STAFF MEMORANDUM
Zoning Administration
August 1, 2019
Item #1

File: PLN17-10836
Design Review and Grading Approval for a New Single-Family Residence
Address: 4320 Bella Madeira Lane, San Jose (APN 654-65-017)

**ATTACHMENT B
PRELIMINARY DESIGN REVIEW AND GRADING APPROVAL
CONDITIONS OF APPROVAL**

MASTER PLANTING PLAN
1/16" = 1'-0"

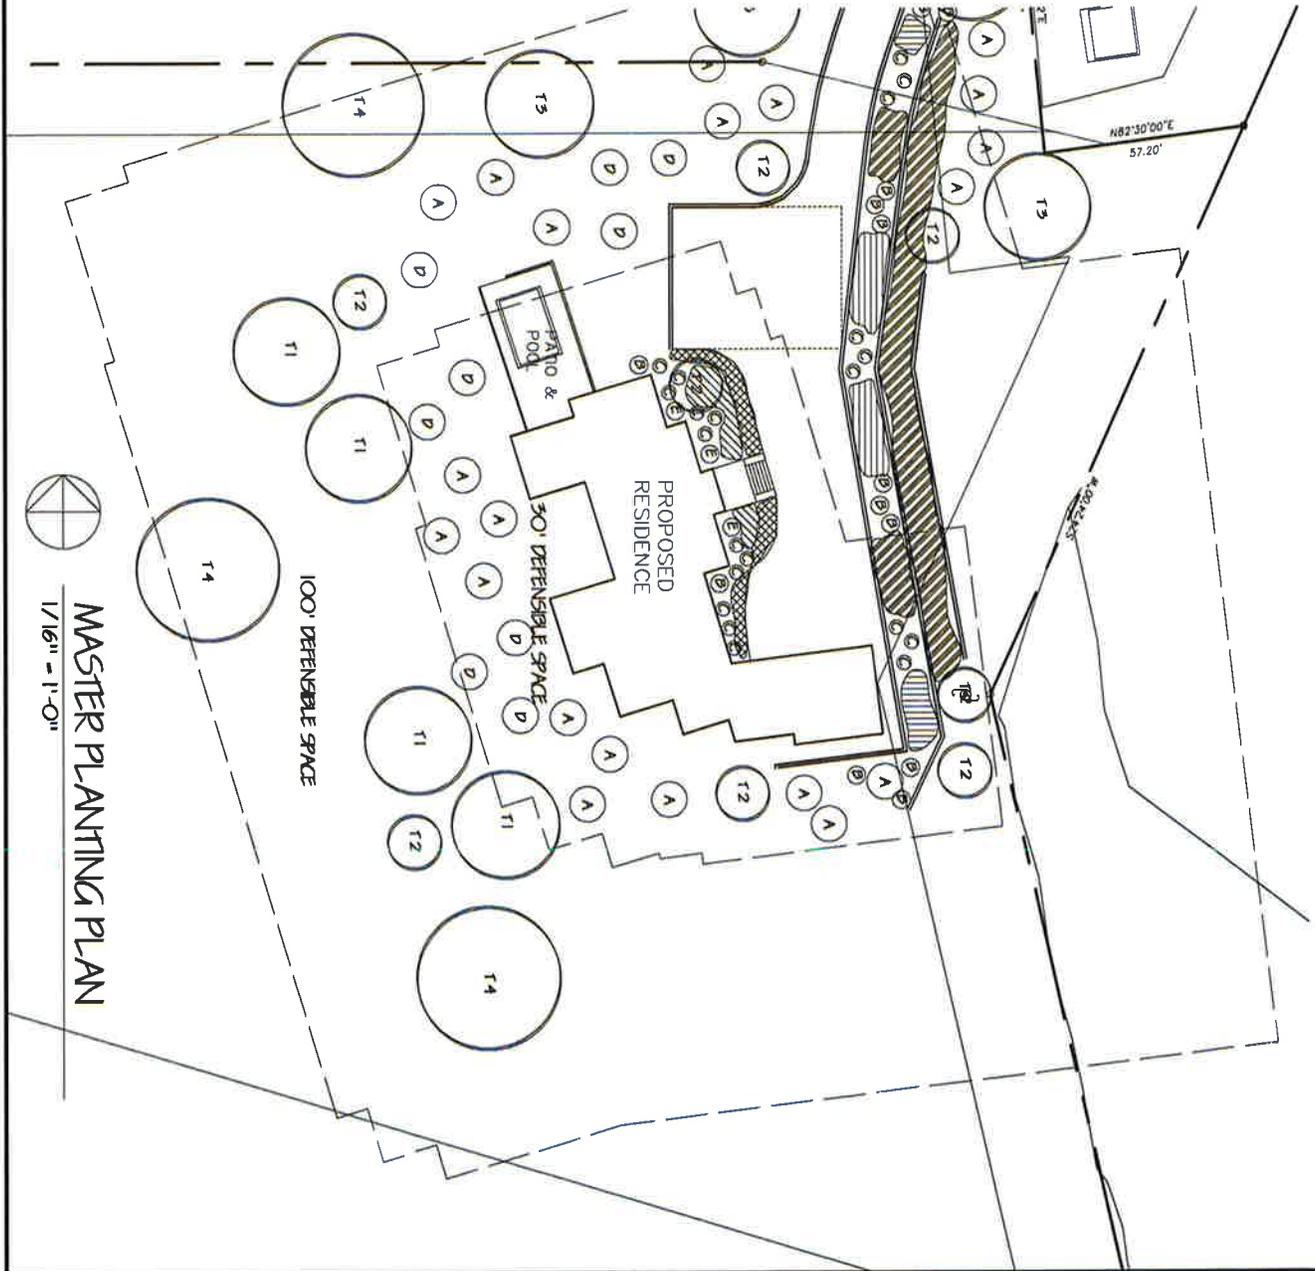
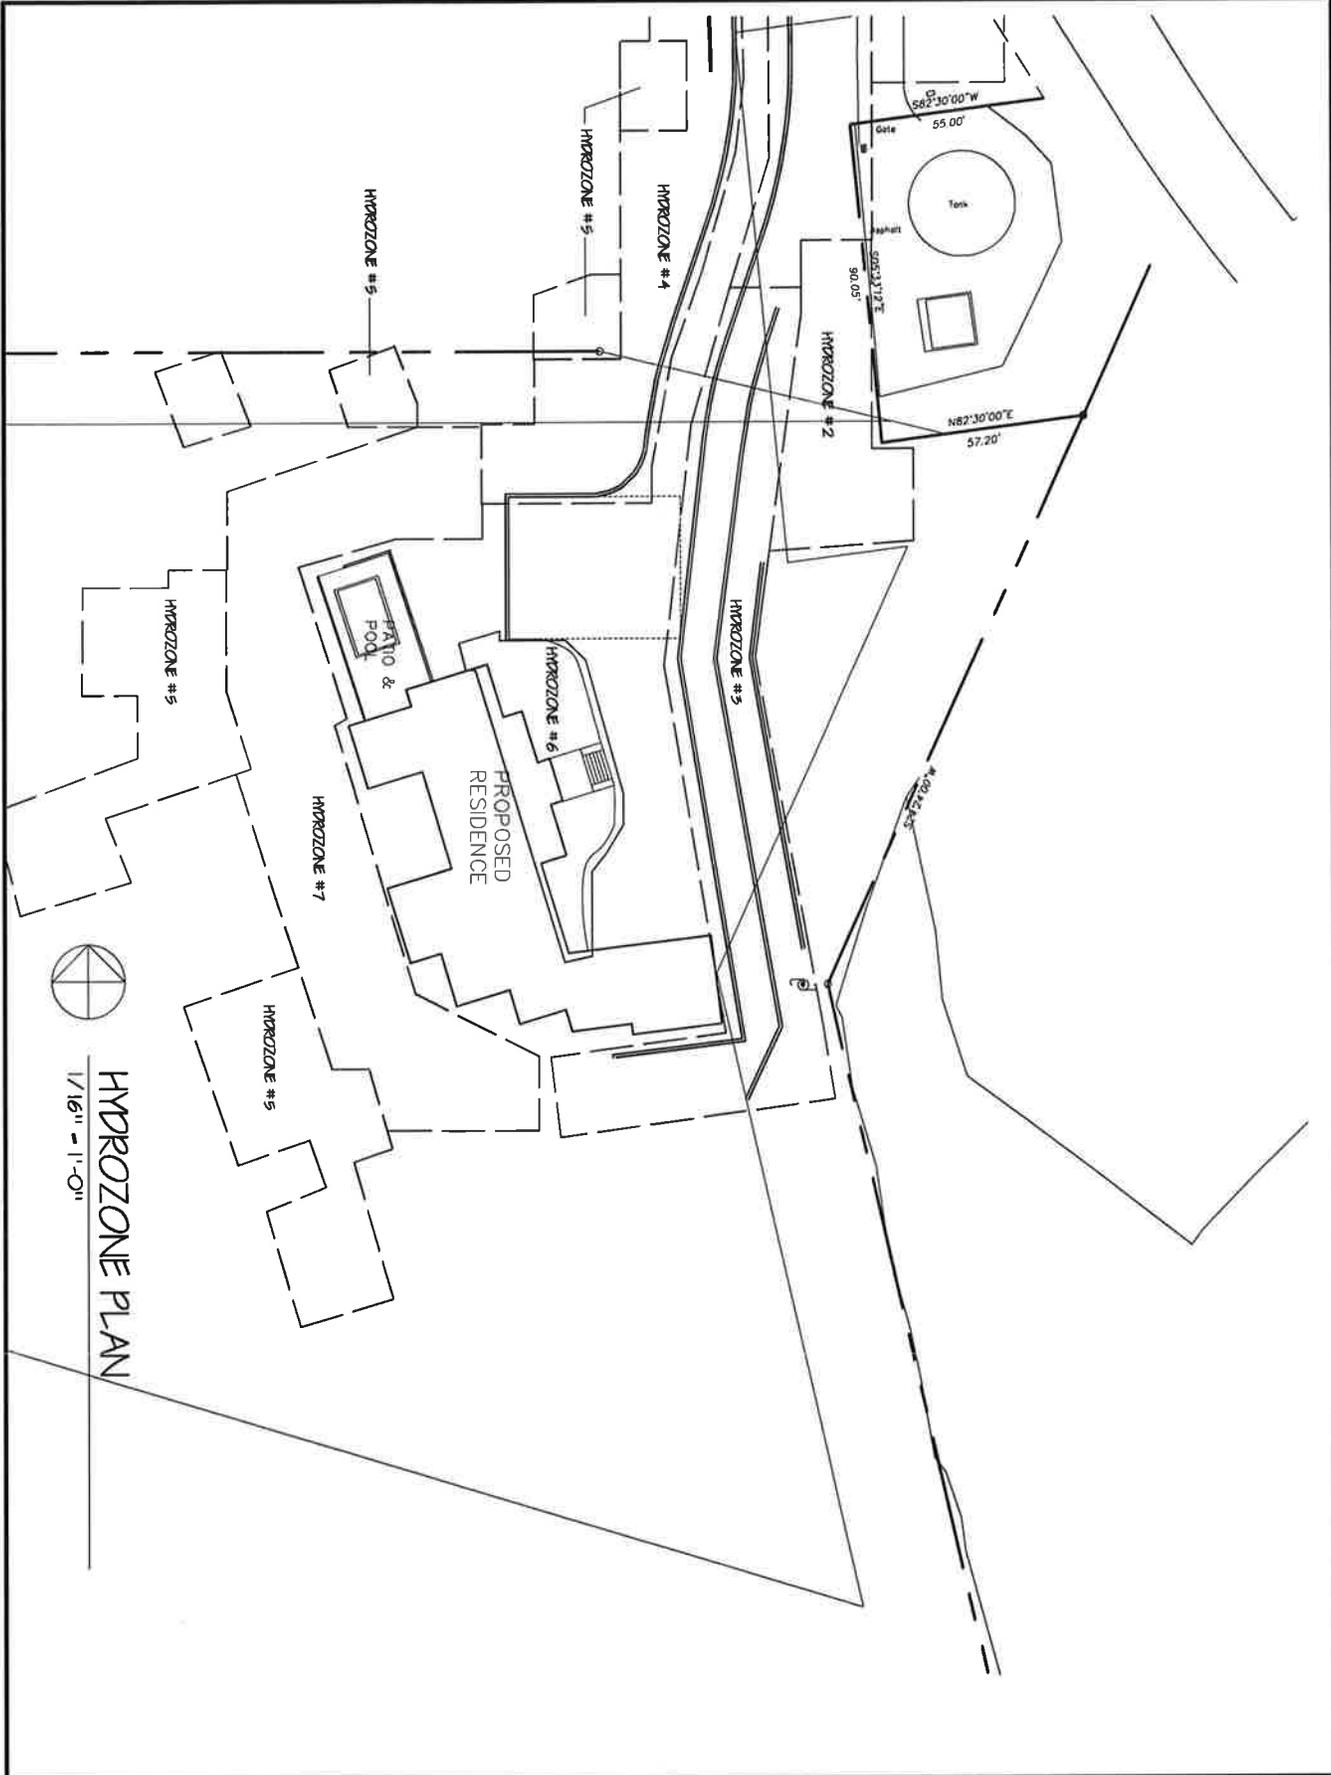
- Submit a landscape plan that shows trees to screen the residence, and hanging vines and shrubs to screen retaining walls as seen from the valley floor and frontage of the lot, including species type, and box size.

- a) 24" boxed screening trees on the lower hillside along the access driveway and surrounding the home on the frontage of the lot and view from the valley floor.
- b) Shrubs and hanging vines to screen retaining walls on the downhill slope facing the valley floor

The Applicant submitted revised plans on July 23, 2019. The revised plans provide a preliminary landscape plan that addresses screening for the residence, and retaining walls. The proposed landscaping includes a mixture of oak, redbud, and pepper trees, and vines (variation including Sedum and Lantana species) to grow over the retaining walls. Additionally, the applicant submitted pictures and renderings of the types of landscaping that is proposed to screen the residence, and walls (see Attachment C). Staff is of the opinion that the proposed landscaping is adequate to screen the residence, and retaining walls. Condition #29 requires that the final landscape plans issued prior to building permit issuance be consistent with the preliminary landscape plans submitted on July 23, 2019.
